### APPEAL SUMMARY

<b>Appeal ID:</b> 22216	<b>Project Address:</b> 222 SW Clay St
<b>Hearing Date:</b> 12/11/19	<b>Appellant Name:</b> Nancy I Strening
<b>Case No.:</b> M-002	<b>Appellant Phone:</b> 5037059768
<b>Appeal Type:</b> Mechanical	<b>Plans Examiner/Inspector:</b> Jeff Donnelly, Thomas Ng
<b>Project Type:</b> commercial	<b>Stories:</b> 7 <b>Occupancy:</b> A-1 <b>Construction Type:</b>
<b>Building/Business Name:</b> Keller Auditorium	<b>Fire Sprinklers:</b> Yes -
<b>Appeal Involves:</b> Reconsideration of appeal	<b>LUR or Permit Application No.:</b>
<b>Plan Submitted Option:</b> pdf [File 1] [File 2] [File 3] <b>Proposed use:</b> Performing Arts

**Code Section** OEESC 503.4.1

**Increase in cooling capacity with omission of required economizer: Granted as proposed.**

1 MECHANICAL ROOF PLAN – NEW WORK  
MS2.09 SCALE: 3/32" = 1'-0"

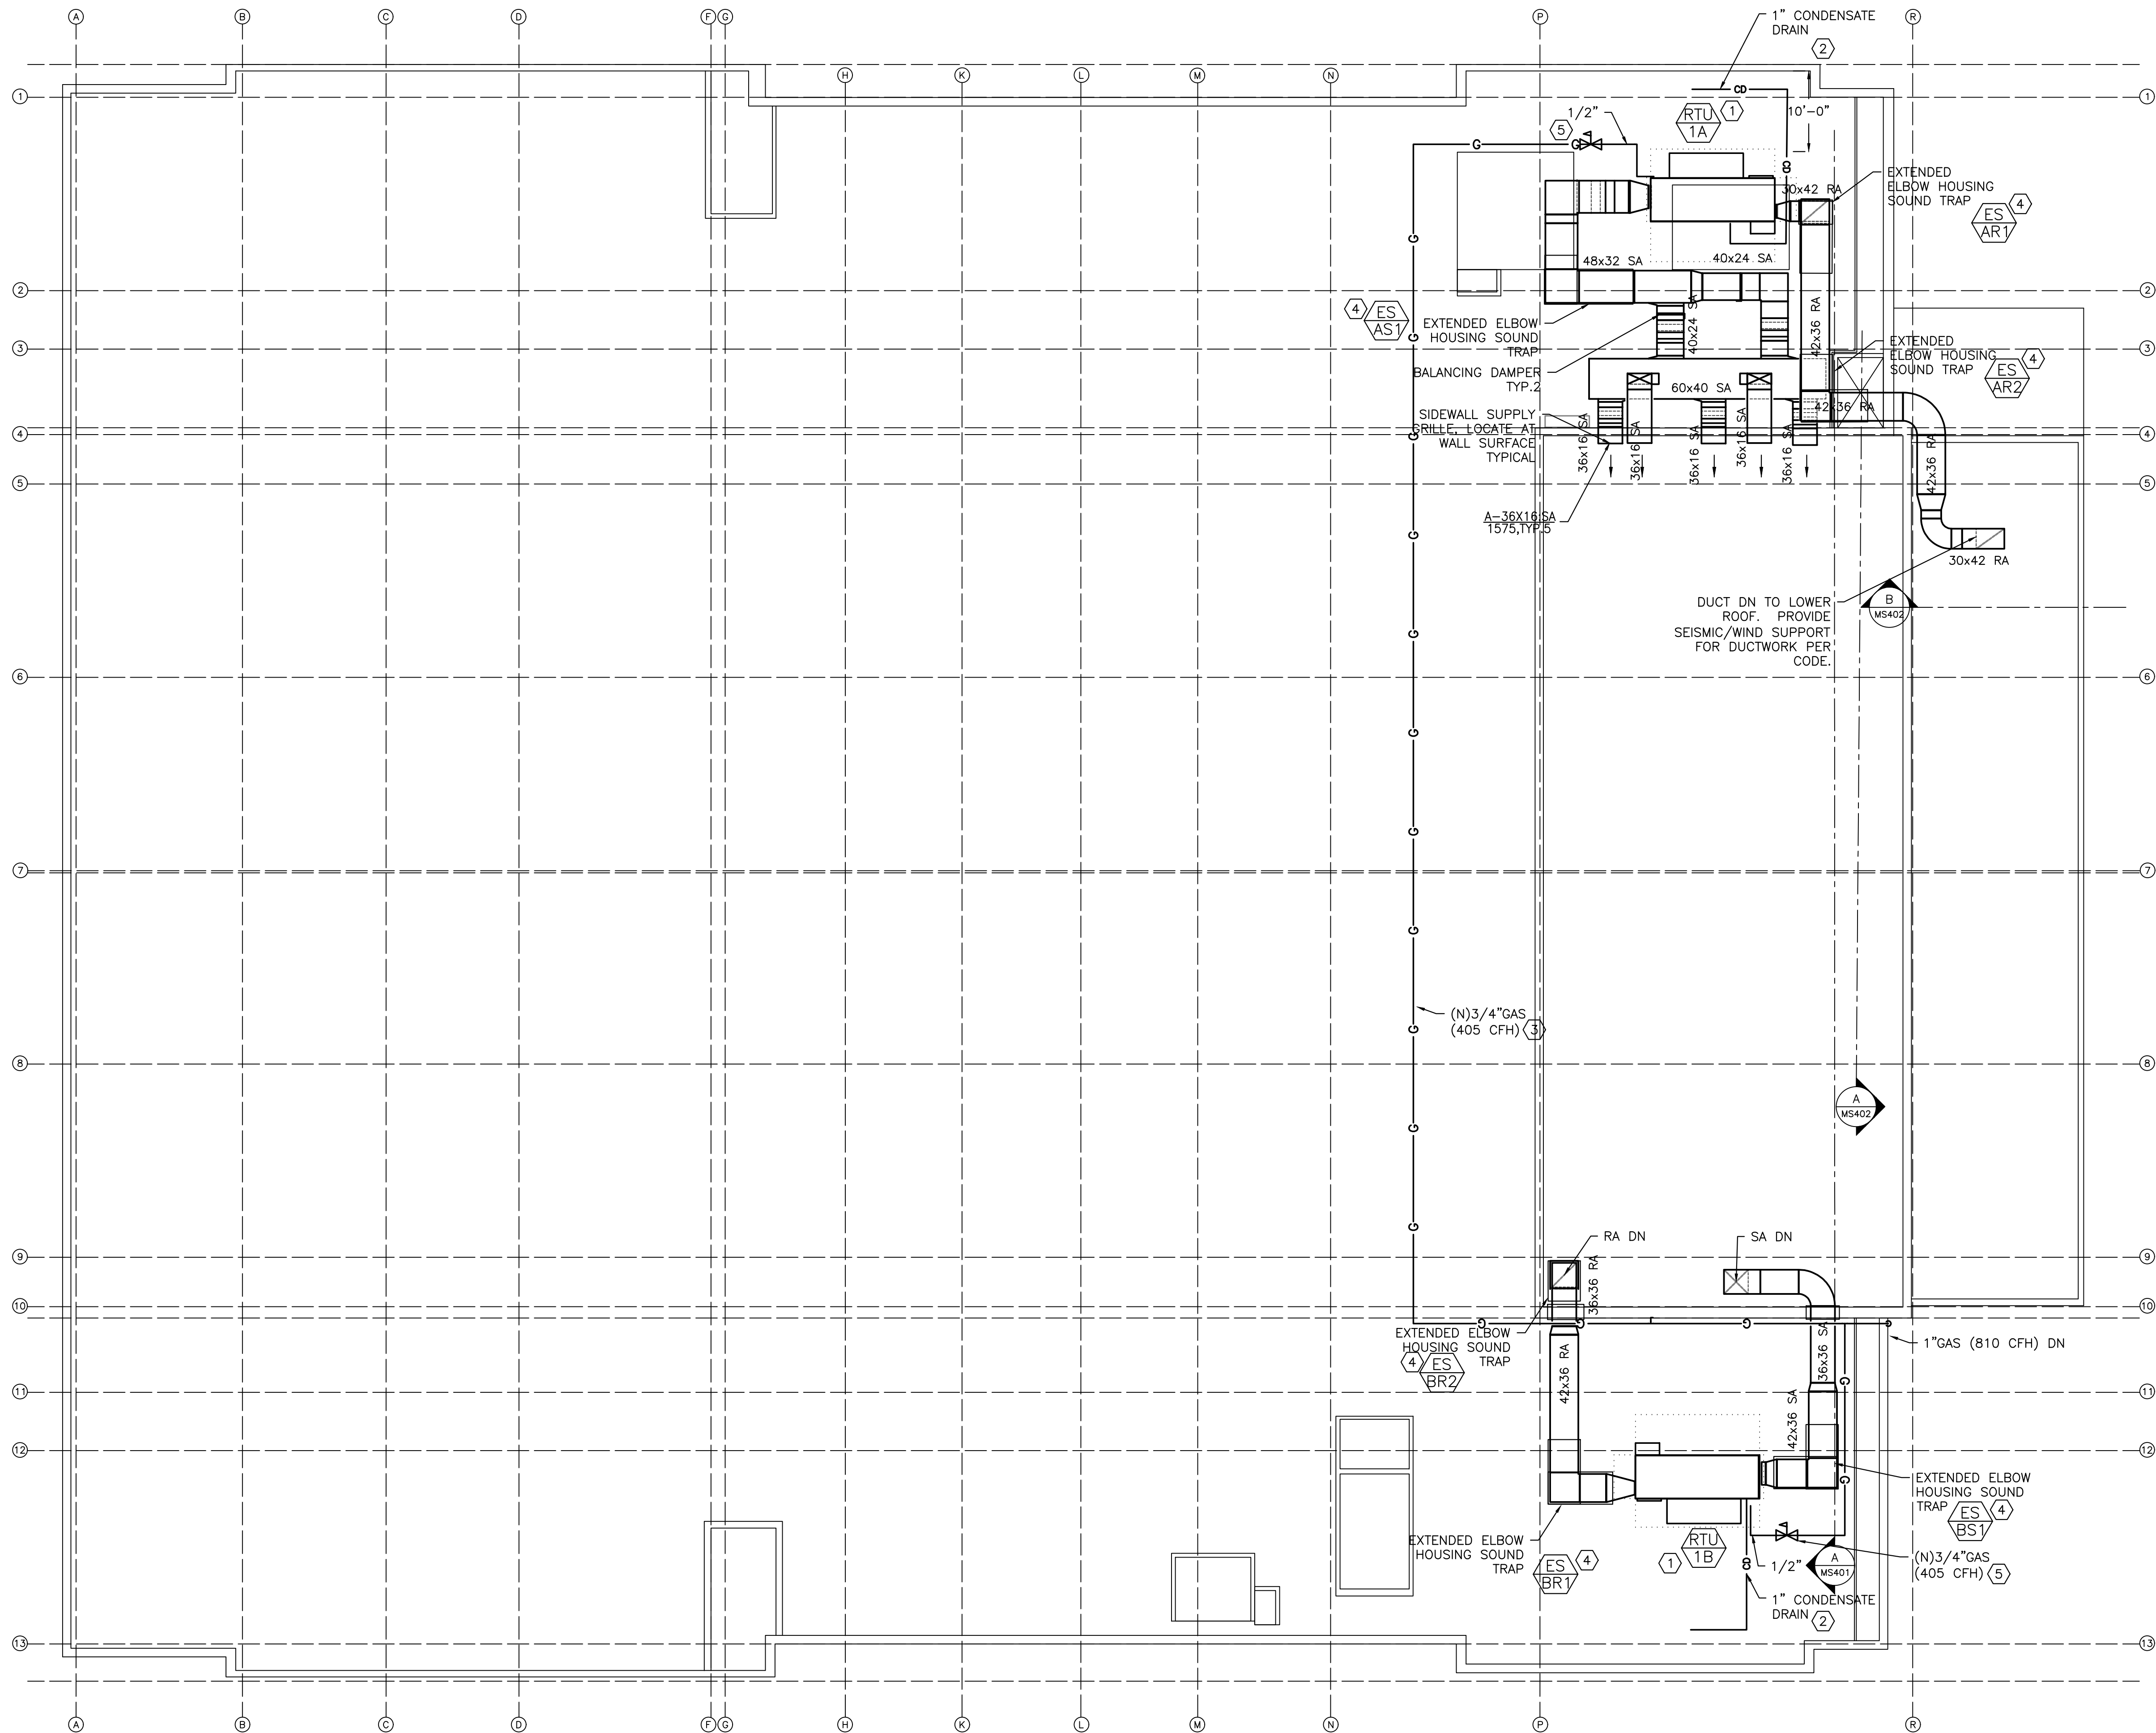
The 7/25/2019 Design drawings (refer specifically to Sheets MS2.09, MS4.01, & MS4.02) call for structural modifications to the roof deck to accommodate the roof-mounted units. Please refer to attached letter dated 10/15/2015 from Metro cPMO Manager to Portland Center's for the Performing Arts Director outlining the barriers to determining additional structural capacity of the Keller Auditorium Roof. Although the 2015 letter was in relation to the roof replacement project initiated the following year, the challenge exists for this stage cooling project: It is impractical to determine additional structural capability of the roof, therefore roof-mounted units are not an option.

**1** MECHANICAL SECTION LOOKING WEST  
MS4.01 SCALE: 3/32" = 1'-0"

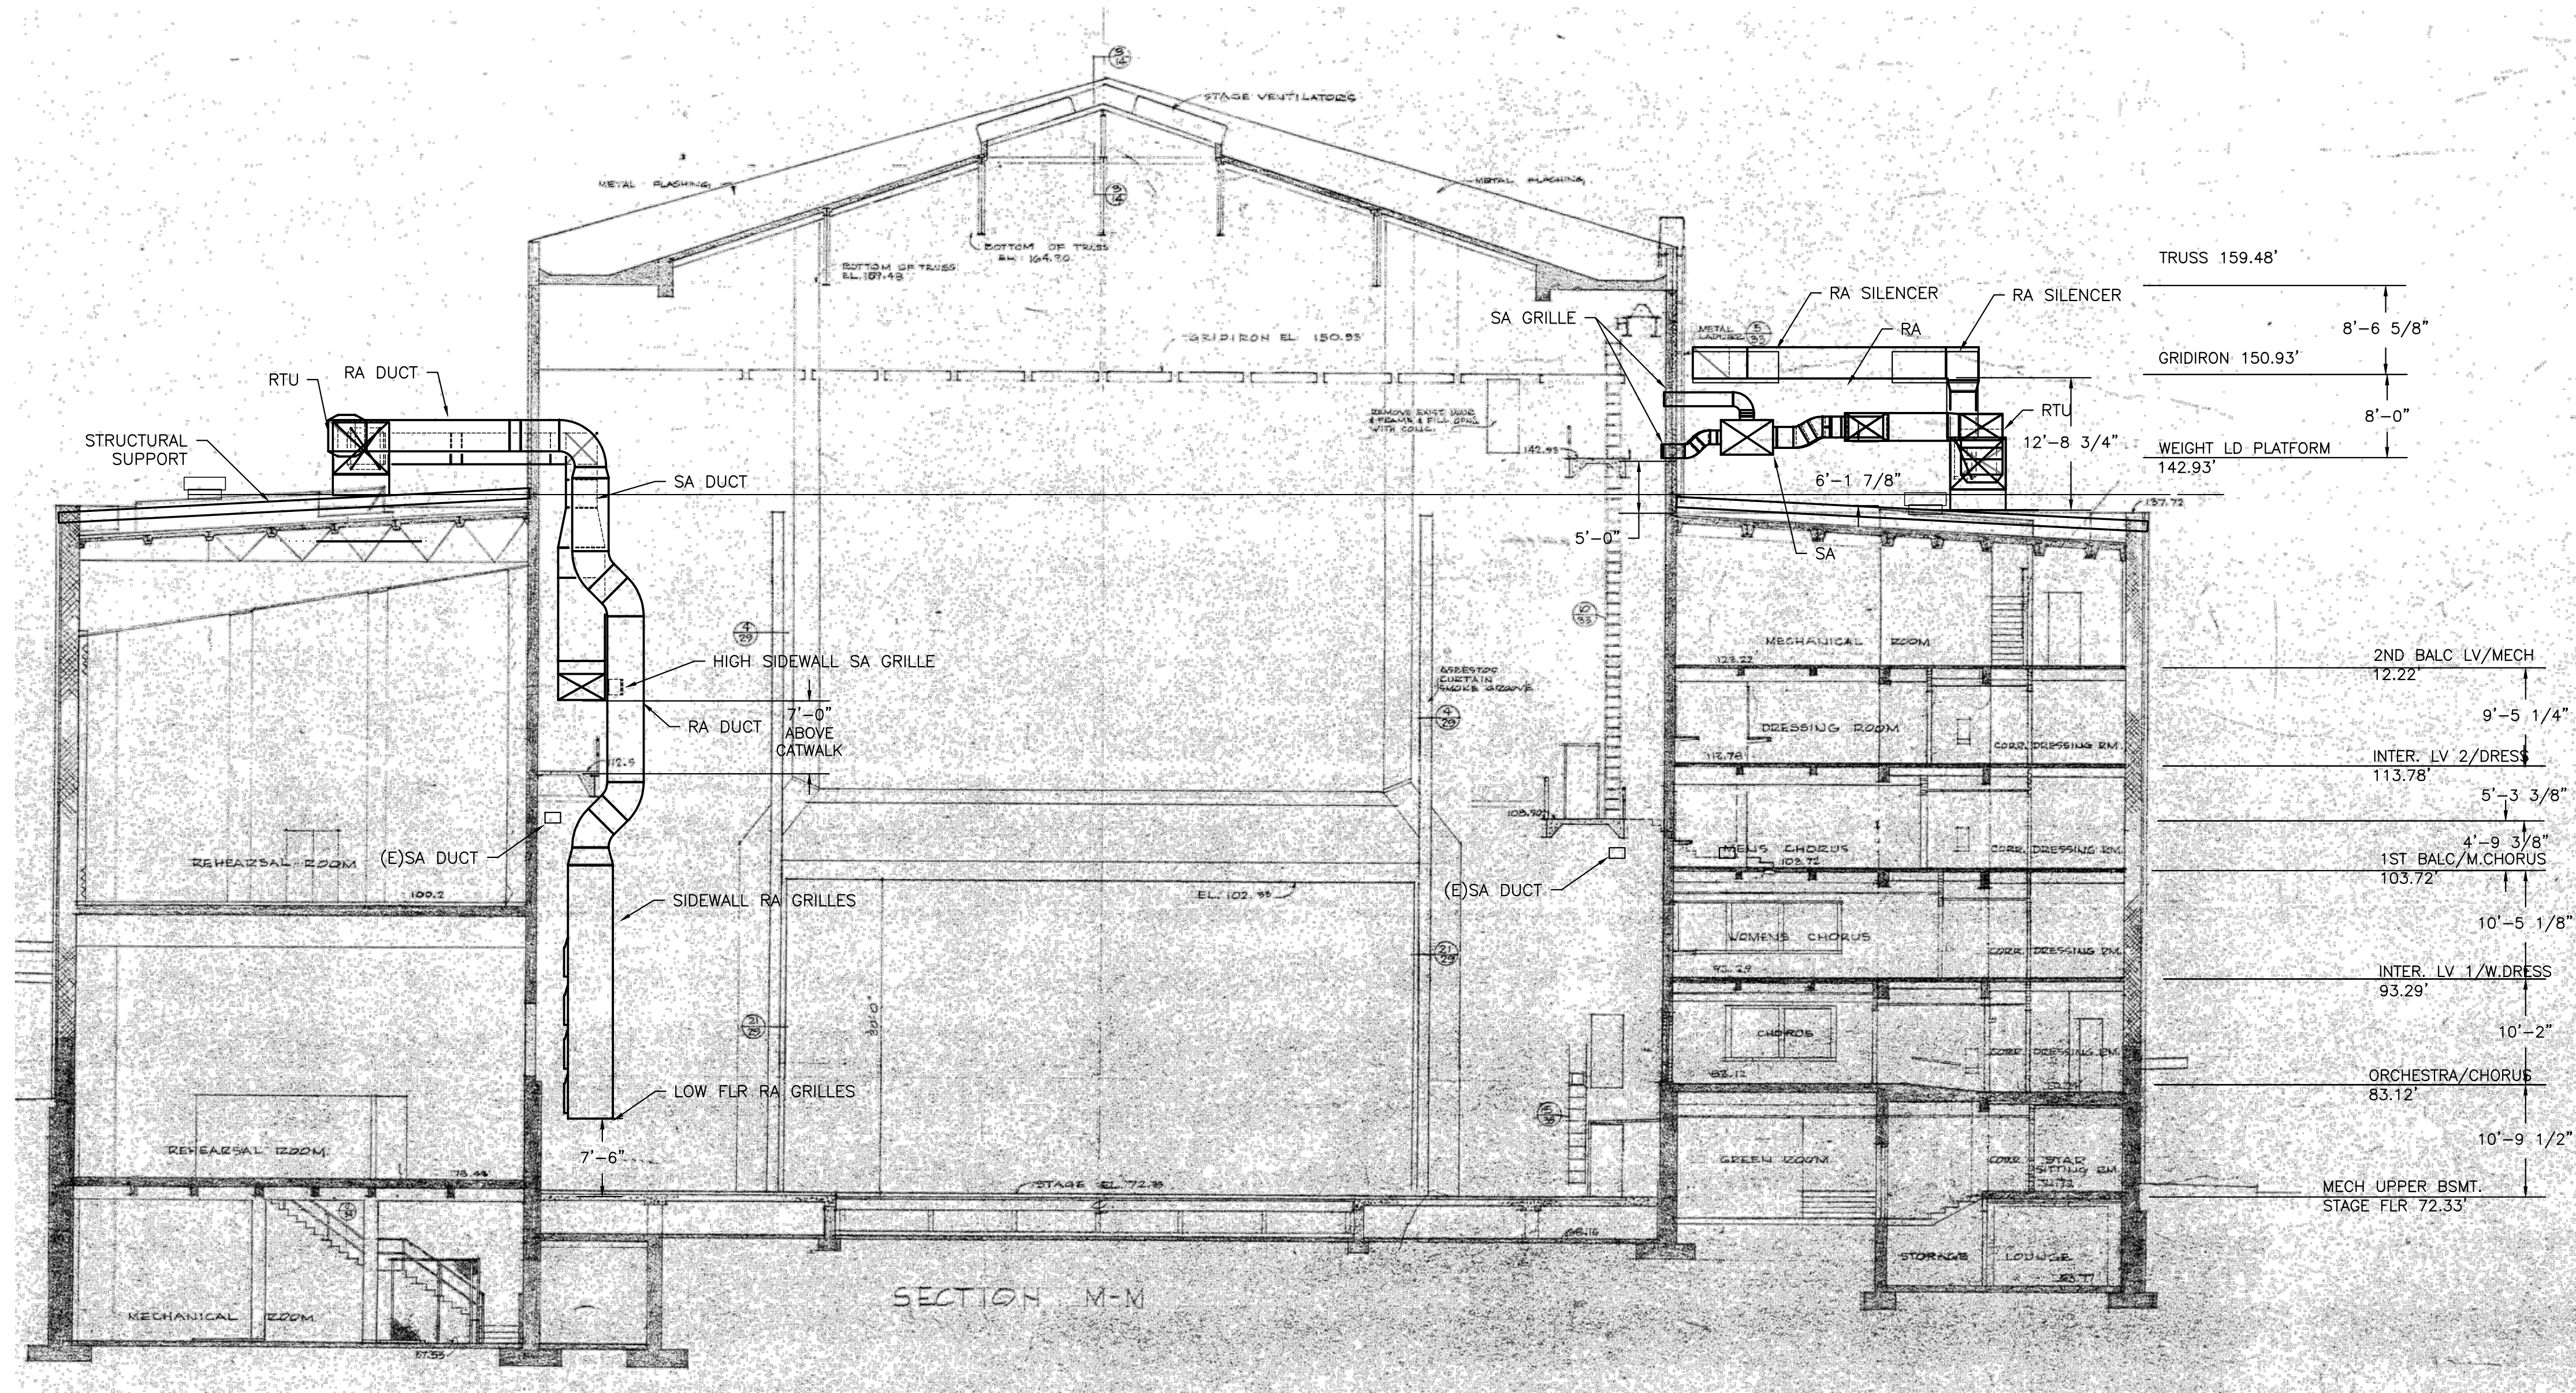
Refer to sheets MS4.01 & MS4.02 of the 7/25/2019 Keller Auditorium Stage Cooling drawings by MFIA, Inc. Engineers for the location/configuration of the ductwork required by the roof top unit solution. This design configuration would require a lengthy and expensive Type II Land Use review and it is unlikely that Metro would receive approval to place ductwork on the exterior of the building.
